Avoidance and Minimization

For Greensboro Loop/US 29 Interchange Redesign

TIP Projects U-2525 B and C

**CONCURRENCE POINT 4A Revisit
January 21, 2010**

SUBJECT: Review of Traffic Noise Analysis
Greensboro Eastern Loop / US 29
U-2525B

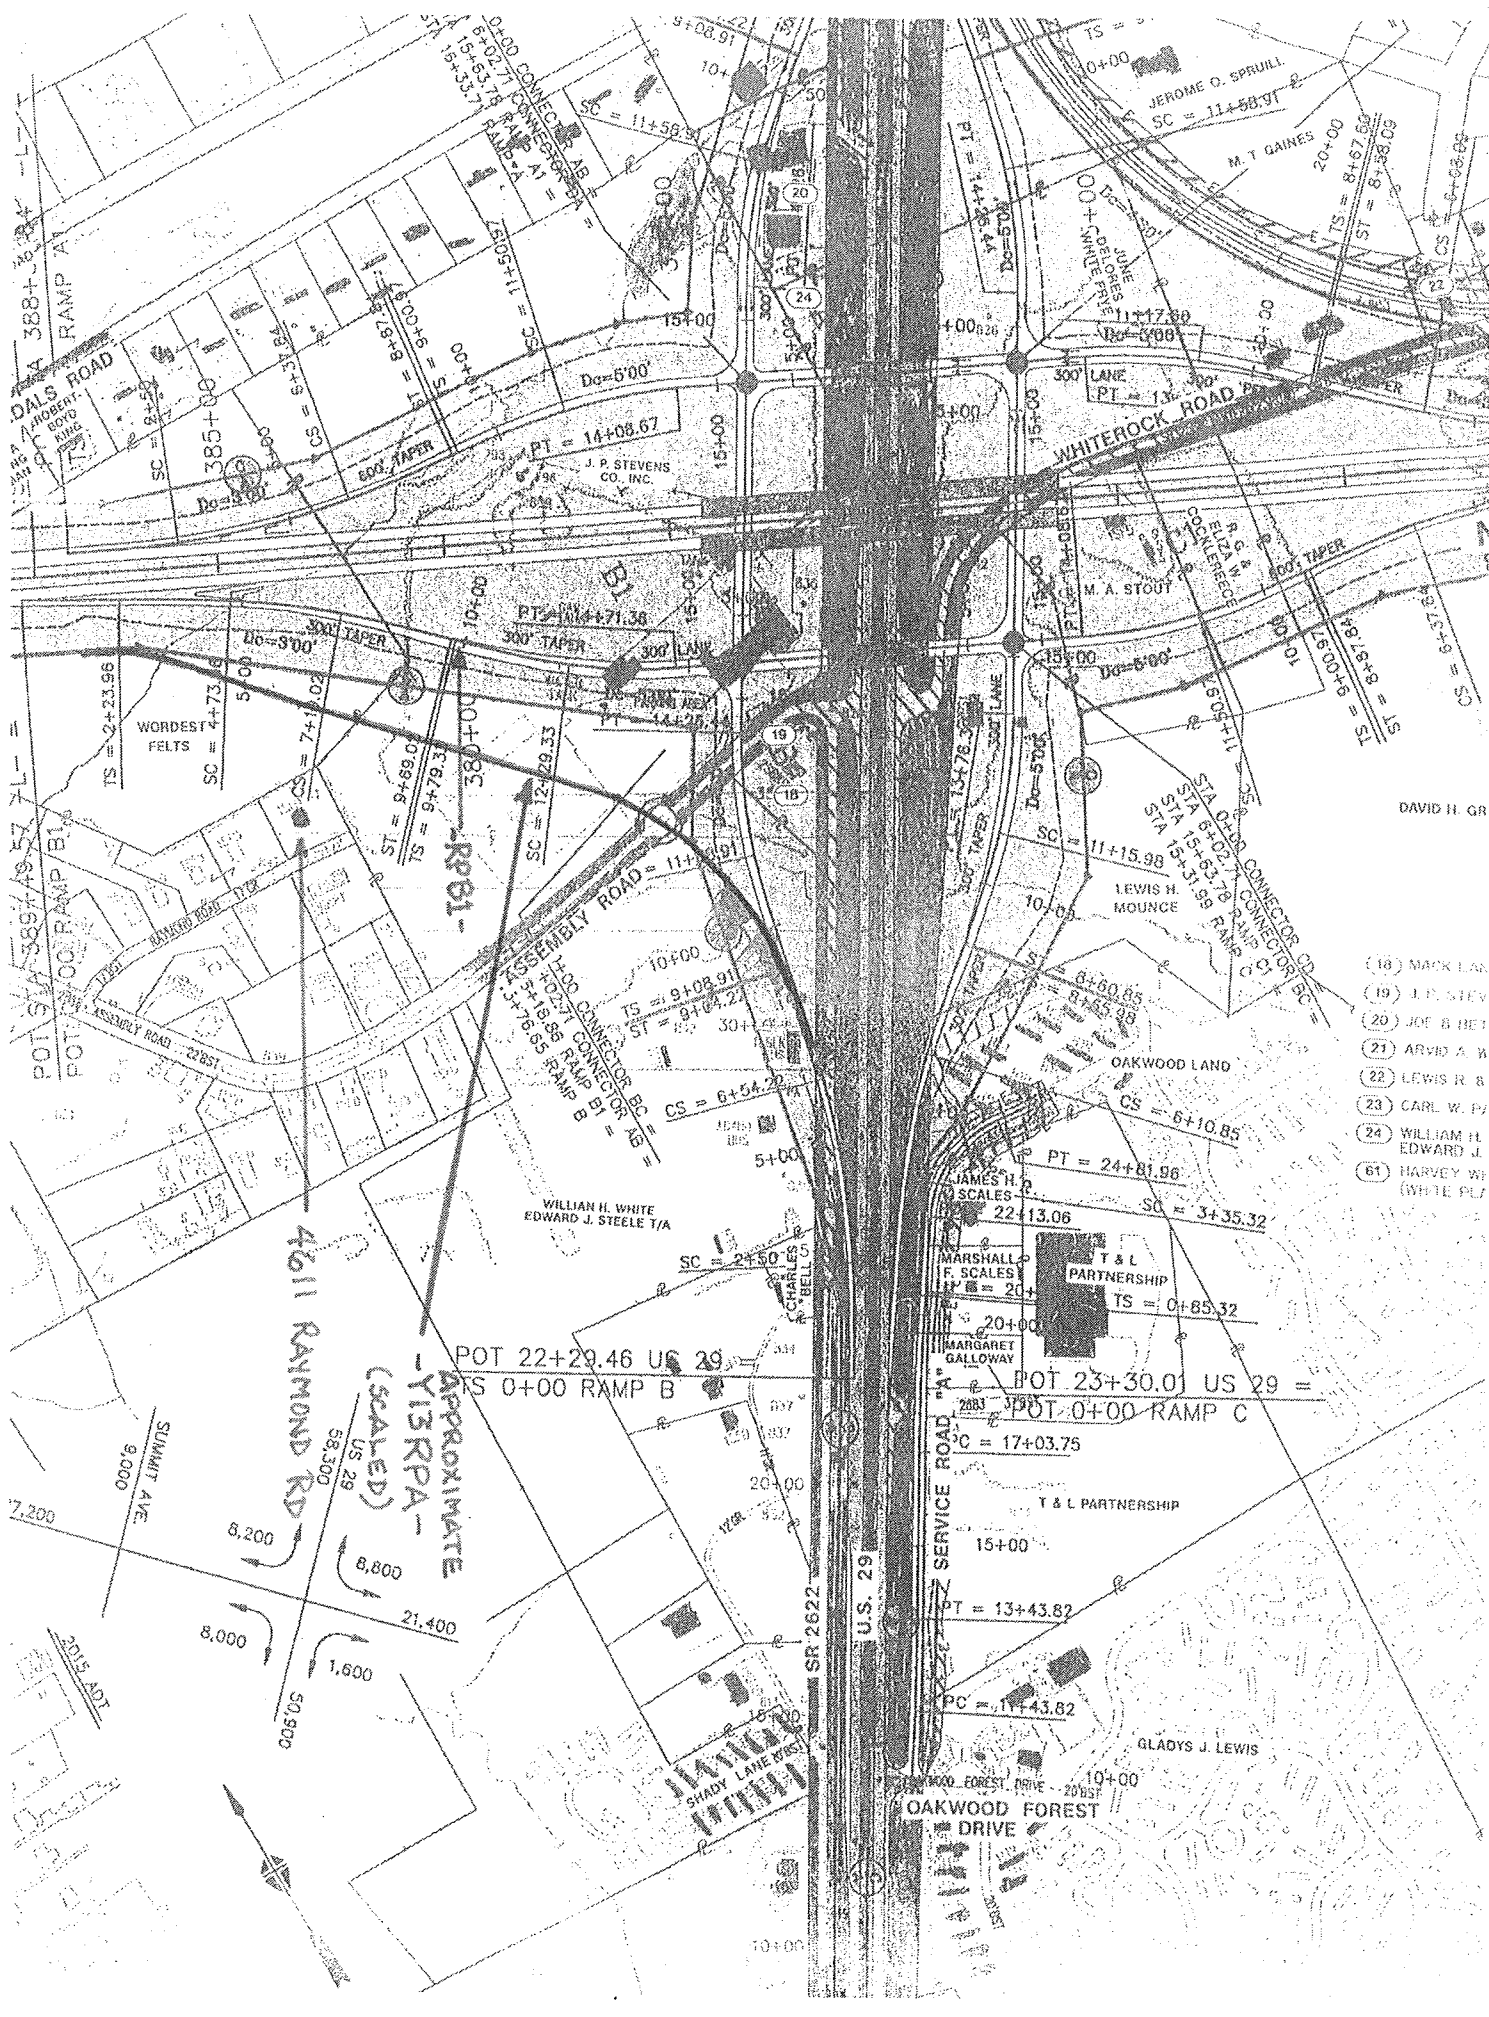
The Traffic Noise & Air Quality Section reviewed proposed realignment of -Y13RPA- to determine whether significant design modifications have occurred with respect to those investigated in our original Traffic Noise Analysis. We compared the current alignment with that found in the original "Texas Box" interchange (see attached plan). No noise abatement measures were recommended for this area in our original analysis.

When a significant design change occurs, it may be necessary to determine noise level impacts on nearby residences caused by the change. The Traffic Noise & Air Quality Group considers a horizontal design modification to be "significant" when an alignment shift moves a travel lane closer to noise receptors by one-half or greater the distance between the original alignment and any residences. Sound levels increase approximately 3 dBA with each halving of distance from their source; therefore, relocating a travel lane to one-half its original distance from residences causes an approximate 3 dBA increase in external noise levels for the residences. A 3 dBA increase is only barely perceptible by most human beings.

We determined that the alignment of -Y13RPA- approximately halves the distance between the original alignment (-RPB1-) and one residence at 4611 Raymond Road. All other residences are located further from the current proposed alignment of all residences in existence on the project's date of public knowledge. Revisions to the original Traffic Noise Analysis are not warranted when only one residence is potentially impacted.

Based upon this information, it is not reasonable, as defined in the NCDOT Traffic Noise Abatement Policy, to investigate noise abatement provisions for any noise receptors in the southwest quadrant of the proposed Greensboro Eastern Loop / US 29 interchange. Please contact me at (919) 431-2010 or at gasmith@ncdot.gov if you need additional information.
